# Applicant Outreach Summary

## SUMMARY OF KEY CHANGES

# PLAN EVOLUTION - SITE PLAN

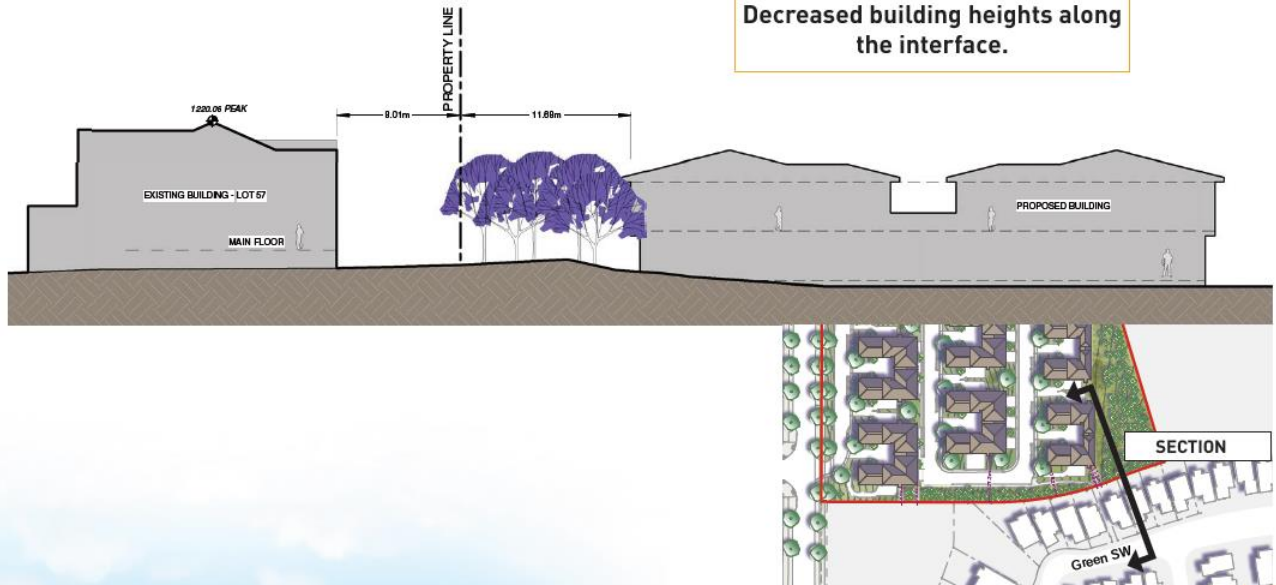
- ✓ Excluded the “Mahood Parcel” from the application based on concerns from adjacent residents.
- ✓ Significantly reduced the overall unit count to 465 units from 730 in the original proposal. This corresponds to a density of approximately 88 units per hectare, with higher densities located in the north portion of the plan area.

- ✓ Revised the Direct Control (DC) district to include two sites based on the M-2 and M-G districts. This was a specific response to community concerns and the M-G site is based on a 135-metre distance from the south property line to ensure a transition from ground-oriented to apartment style forms.

- ✓ The DC proposes to increase the minimum setback to 8.5 metres along the south boundary (interface to the existing community) and the overall height to 24 metres to accommodate the topographical nature of the site.

- ✓ Addressed all technical concerns, specifically relating to traffic along 77th Street. Introduced frontage road along 77th Street, maintaining an attractive pedestrian environment (See Page 10).
